May 11, 2017

SUBJECT: Addendum Number 2
Old St. Paul's Evangelical Lutheran Church
Narthex Addition

FROM: Ramsay Burgin Smith Architects, Inc.
225 North Main Street - Suite 501
Salisbury, NC

ABD | |

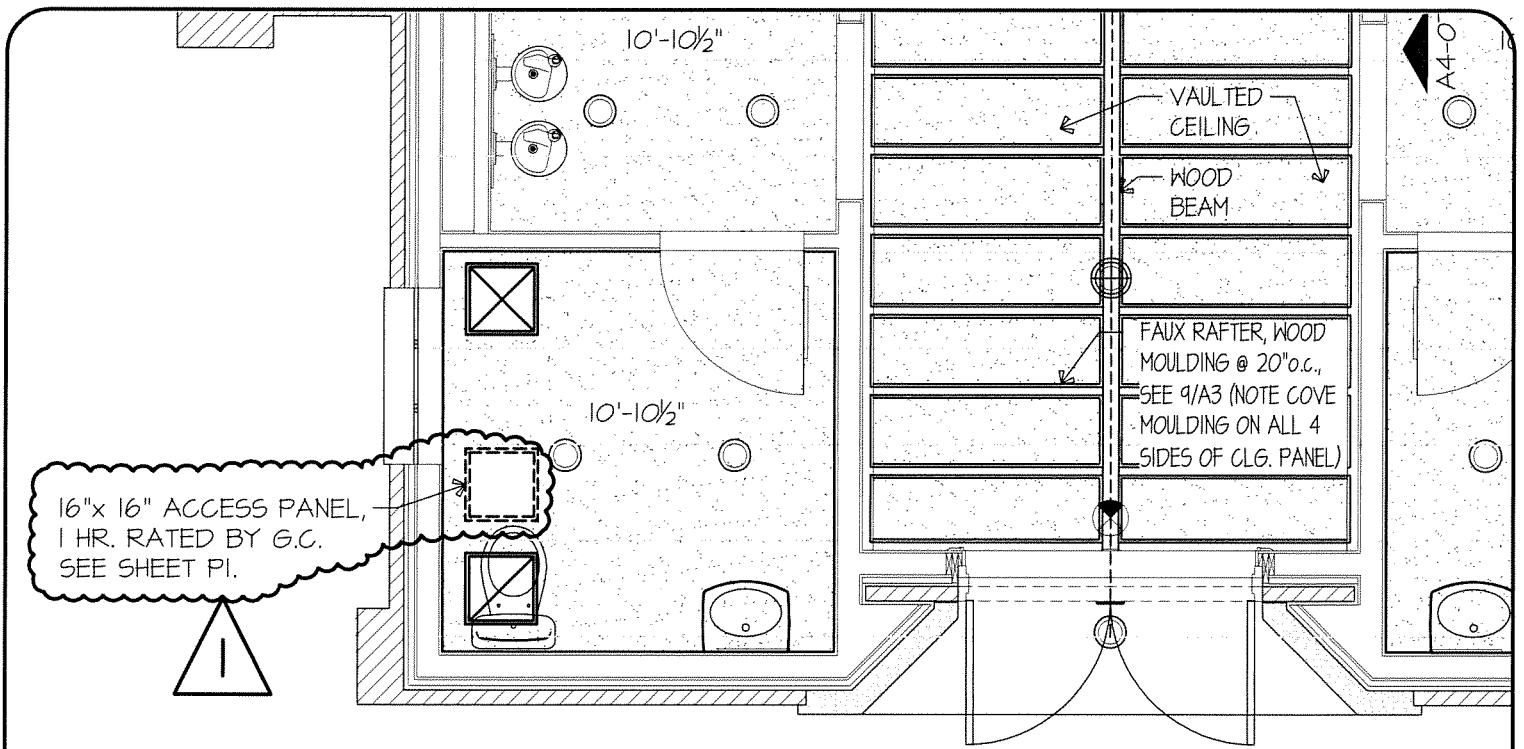
Item 4 - Reference Sheet C1 – Site Plan and Planting List

See Bulletin drawing ABD1.1 - Note that 2 plants were added to the lower side of the new building addition to act a screen for the three mechanical units bringing the total number of Korean Boxwoods on the Plant Schedule to 11.

ABD2.1

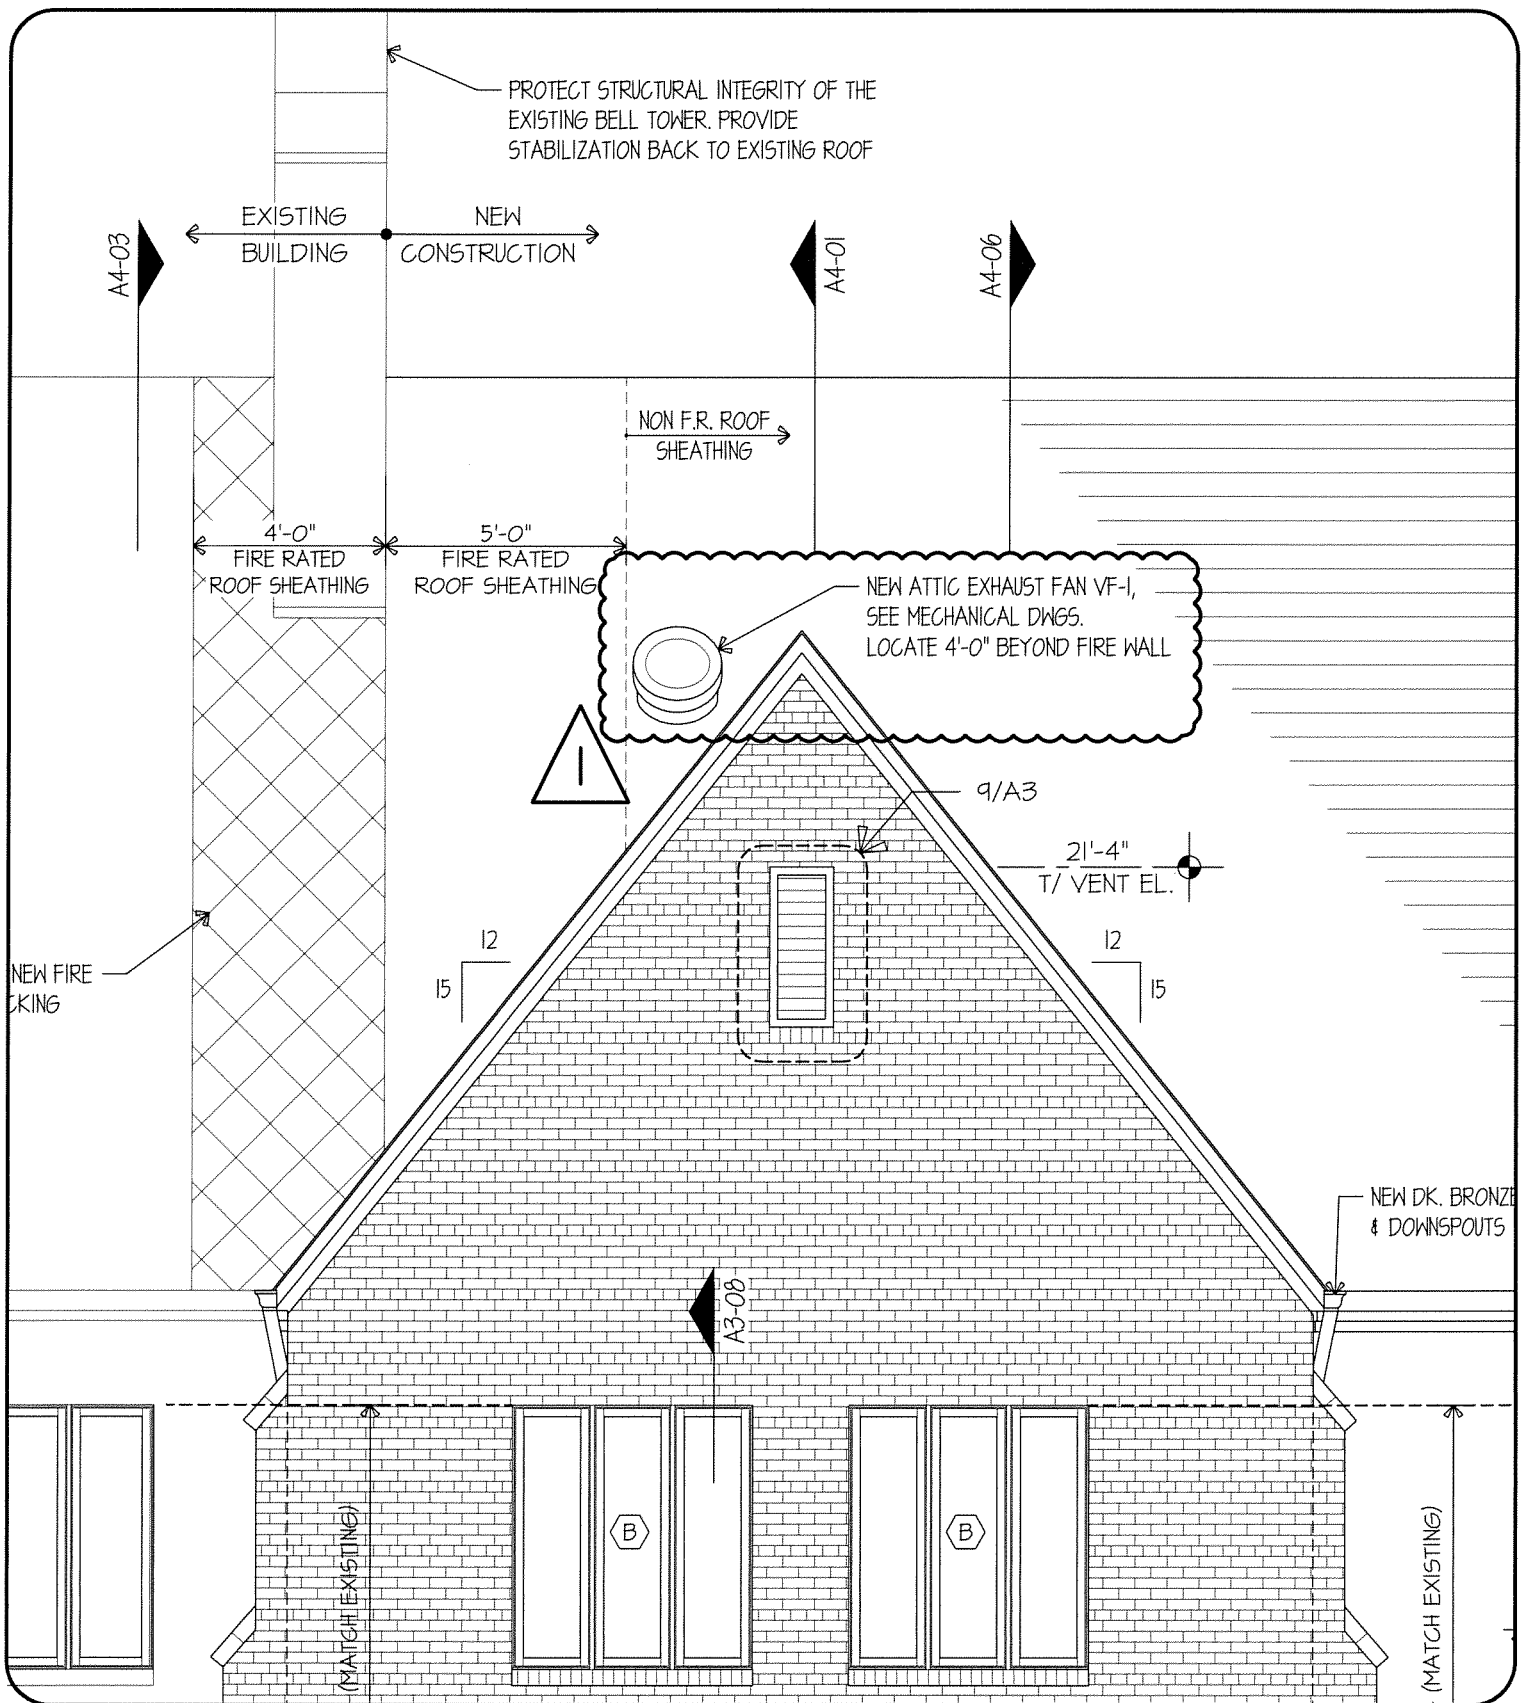
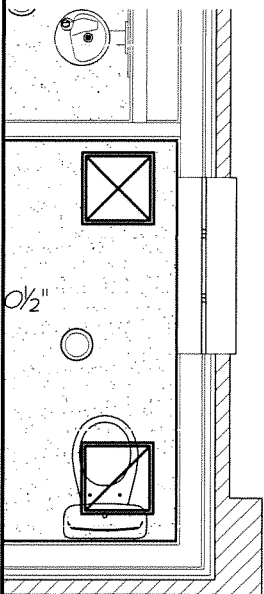
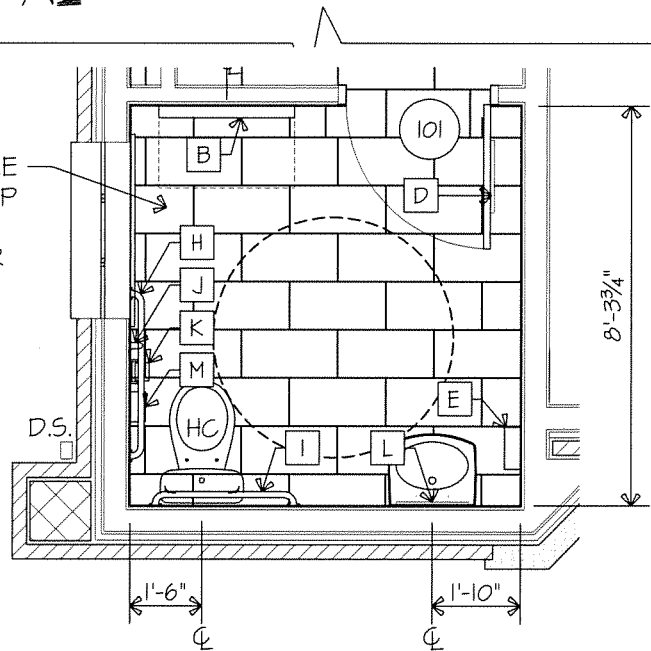
Item 2 - Reference Specification Section 09300 – Tile and the Room Finish Schedule drawn on 5/ A2:

12" x 24" floor tile is being used in lieu of the 12" x 18" called in the Room Finish Schedule as "F1" since Dal Tile "Portfolio Colorbody" porcelain tile isn't available in 12" x 18". The joints of the tiles are staggered on tile centers between rows. See the Tile pattern illustrated on the bottom of ABD2.1.

Item 3 - Reference Specification Section – 08305 – Access Doors

Provide one 16" x 16" 1 hour rated white powder coated steel ceiling access door in Women's toilet 101 to access the water valve located above the ceiling. Provide J.L. Industries (or equal) model FD/1 hour rated for wall board flange with screw turn latch. See bulletin drawings ABD2.1 – Partial Reflected Ceiling plan for location and see the reference to the access door (by G.C.) in the plumbing addendum items.

ABD3.1

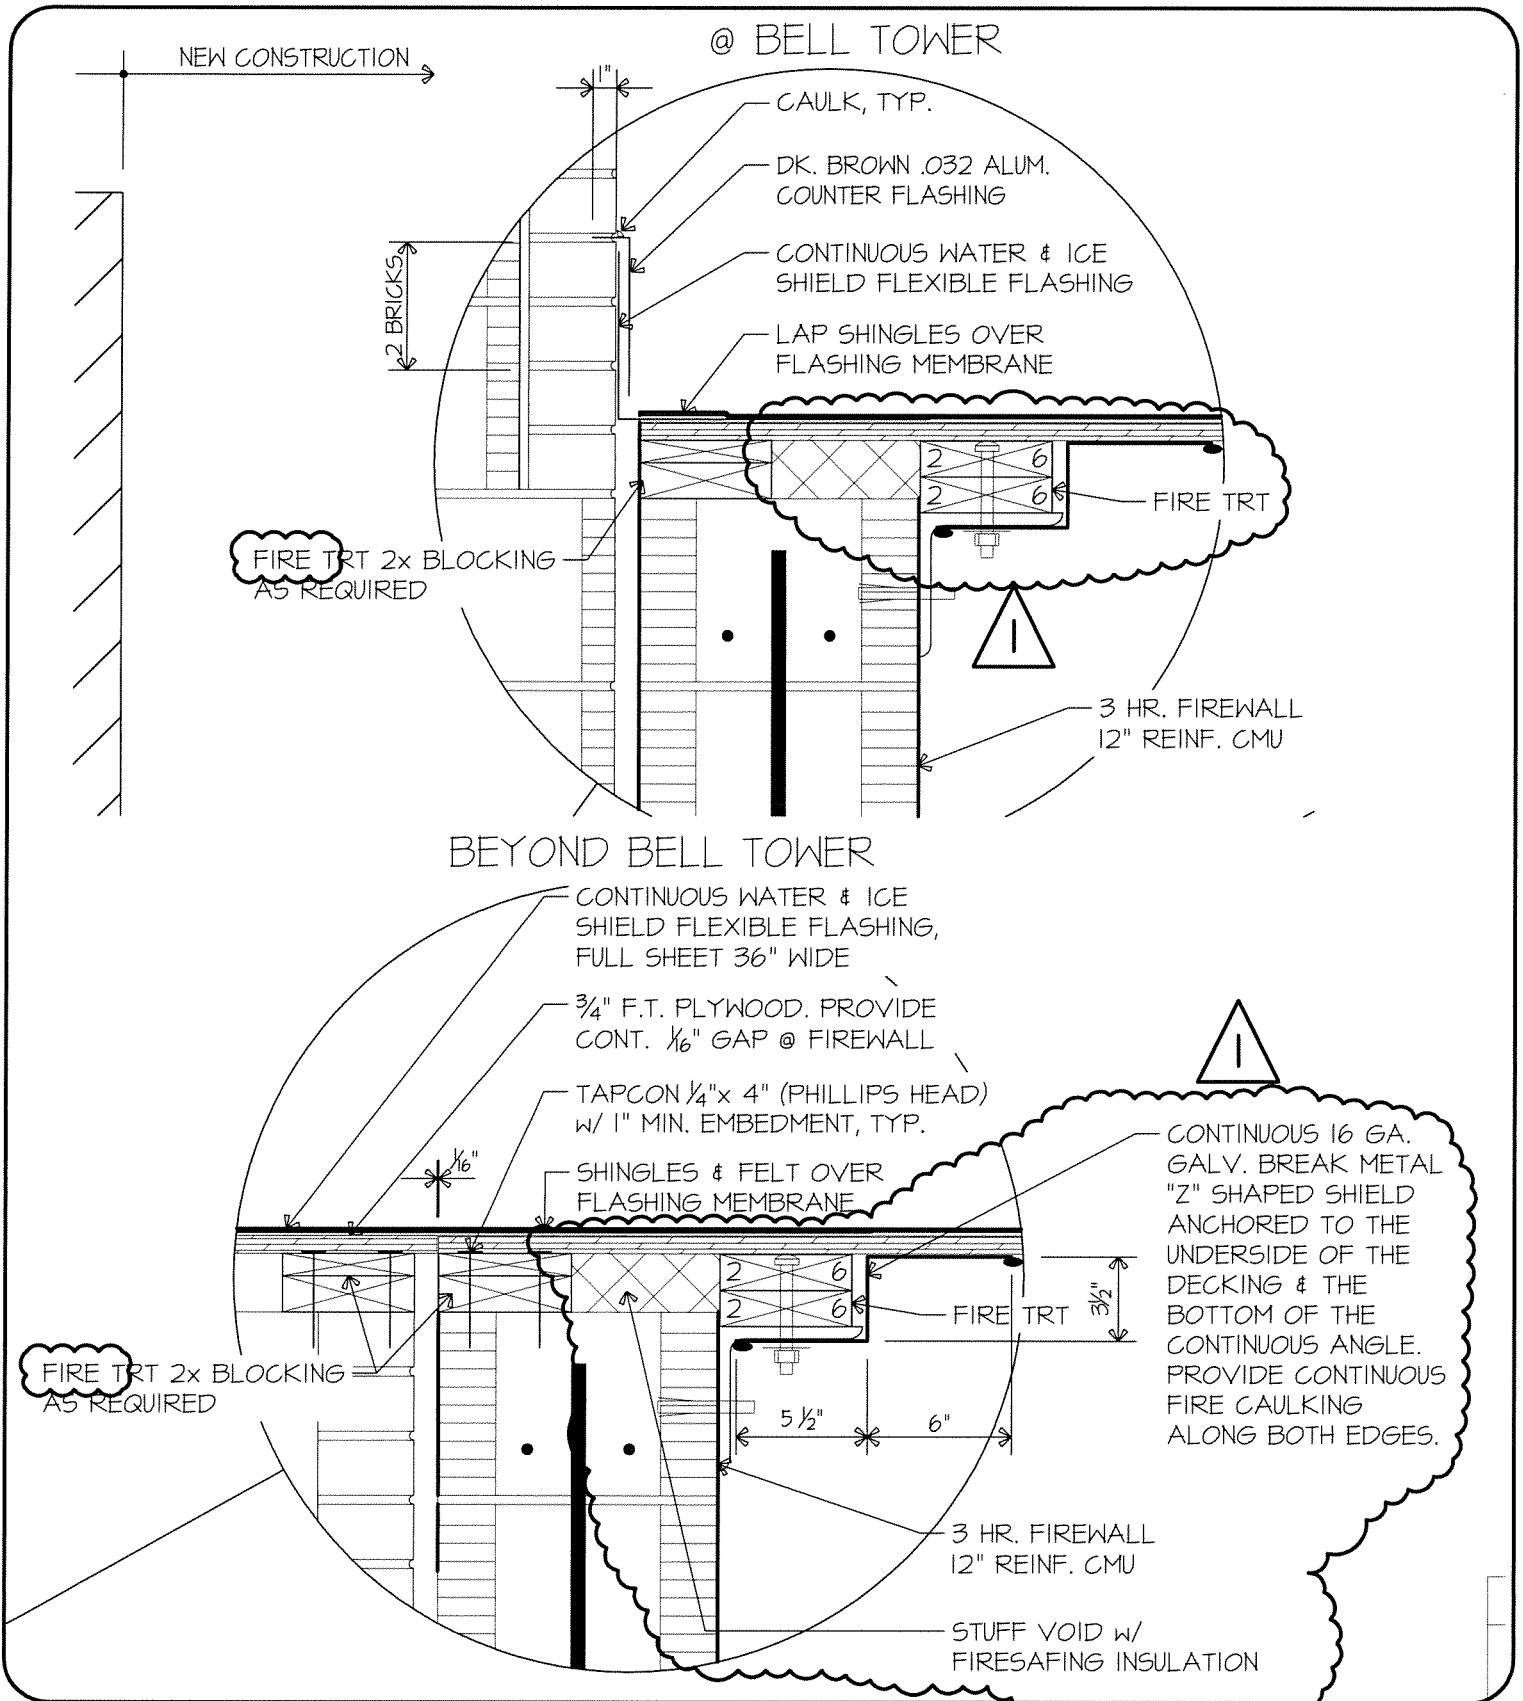
Item 5 - Reference Sheet A3 Elevation 3/A3:- South Elevation

See Bulletin drawing ABD3.1 that shows the attic exhaust fan (by M.C.) relocated at least 4 feet away from the firewall. The revised bulletin drawing shows the fan more correctly drawn without a tall turbine.

SHEET NO.
ABD4.
OF

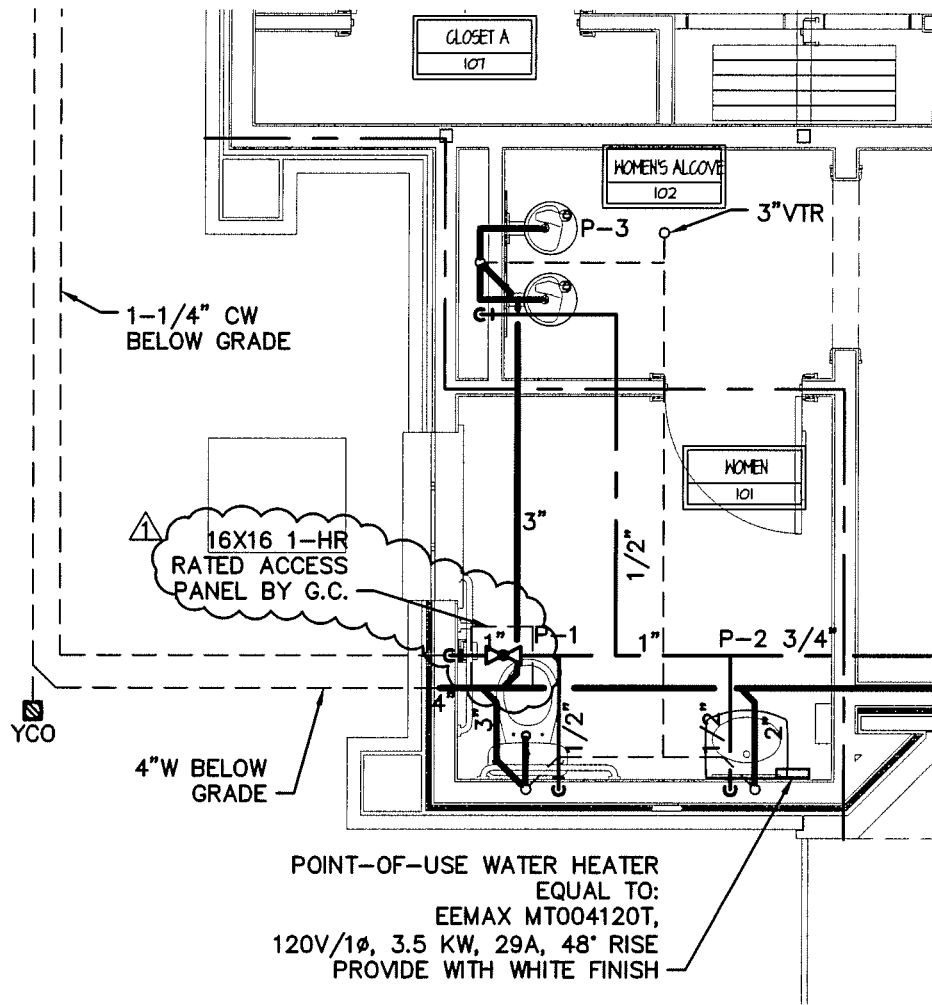
Item 6 - Reference Sheet A6: Wall Sections- the Left Sheet Side Wall Section .

Reference the wall section at the firewall. At the top of this section where the 8" and 12" CMU abuts the belfry tower and the adjacent existing building roof, a fire and smoke stop needs to be installed according to the Building Official utilizing a UL rated joint detail for 3 hour wall. We cannot find a U.L. detail for that specific condition. For bidding purposes, we have revised the two circular enlargement details at the top of the sheet to show a sealed up joint utilizing firesafing stuffing, a "Z" shaped 16 gage metal shield applied against the 6"x 6" x 5/16" angle (see 7/S1.20) with firecaulking sealing the top and bottom edges of the shield edges to the firerated roof deck and the CMU firewall.

See Bulletin ABD4.1. This protection detail is provided and installed across the entire roof width. Should a different solution be found that is satisfy the Building Inspector we will settle up any difference in cost with the GC.

Please note that we changed the 2x blockings to Fire Treated lumber on both sides of the firewall..
